HISTORIC PRESERVATION COMMISSION
STAFF REPORT
September 6, 2023

Title:	Metropole Siding and Window Rehabilitation
Project:	Historic Preservation HP-23-0007
Location:	306 2 nd Street (217 D Street)
APN:	001-093-016
Applicant:	Dave Gaddis
Property Owner:	Evo and Catherine Fanucchi
Purpose/Use:	Replace siding and windows on south-facing building façade
Application Date:	July 17, 2023
General Plan:	C-RC – Core Retail Commercial
Zoning:	CW – Commercial Waterfront
CEQA:	Exempt under §15331, Class 31 Historical Resource Restoration/Rehabilitation
Staff Contact:	Millisa Smith, Assistant Planner
Recommendation:	Hold a public hearing; and Adopt a resolution finding the project is exempt from CEQA and approving with conditions
Motion:	<i>“I move the Historic Preservation Commission adopt a resolution finding the project is exempt form CEQA and conditionally approving the Metropole siding and window rehabilitation at 306 2nd Street.”</i>

Figure 5: Existing and proposed siding side-by-side

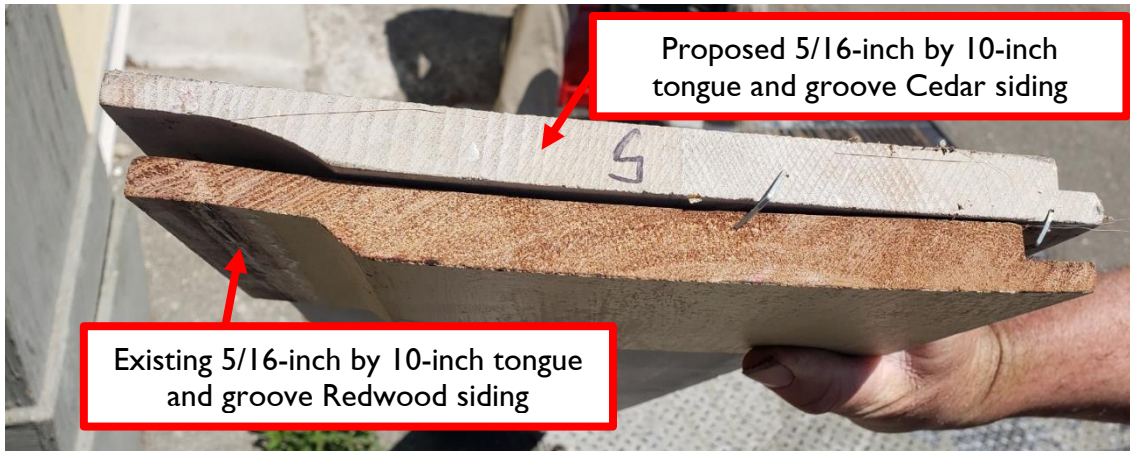
The applicant is proposing to replace the existing deteriorated and rotted 5/16-inch by 10-inch Redwood tongue and groove siding (Figures 3, 4 and 5), which was installed during the 1977 renovations, with 5/16-inch by 10-inch tongue and groove Cedar siding (Figure 5), for the entirety

Figure 9: Rendering of proposed art area where boarded window previously existed

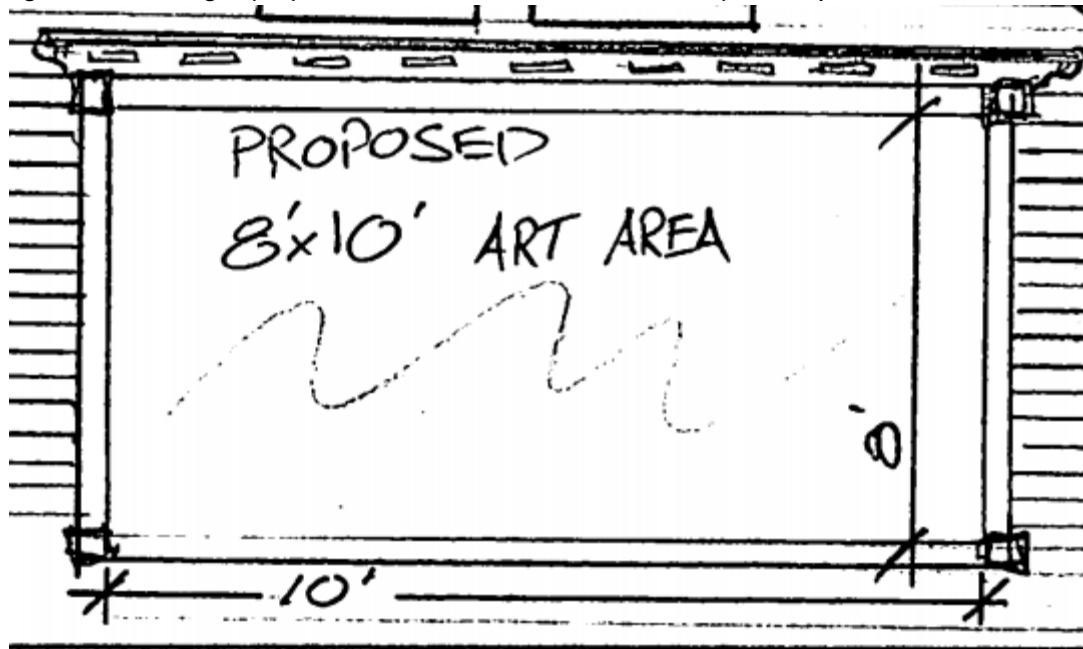
In the lower western corner of the south-facing building façade, a two-section approximately five-foot by eight-foot window originally existed. Sometime between 2007 and 2012, the lower section of the window was boarded, and sometime between 2017 and 2018 the upper section of the window was boarded and the interior of the building was drywalled where the window existed (Figure 8). At the July 17, 2018 meeting of the Arts and Culture Commission, a mural of the Madaket boat was approved for this location and the mural

was painted during the 2018 Eureka Street Art Festival. According to the applicant, during the earthquake on December 20, 2023, the mural suffered damage and cracked, after which moisture was leaking into the wall behind it. When the siding was removed prior to this application, the window frame and the mural it contained were removed as well. The applicant is proposing to install an eight-foot by 10-foot framed art area, with decorative framing and trim to match other decorative features on other façades of the building, where this framed mural previously existed (Figure 9). The applicant intends to provide this space to an artist in the future for a mural of some historic nature, with approval by the Arts and Culture Commission no longer required.
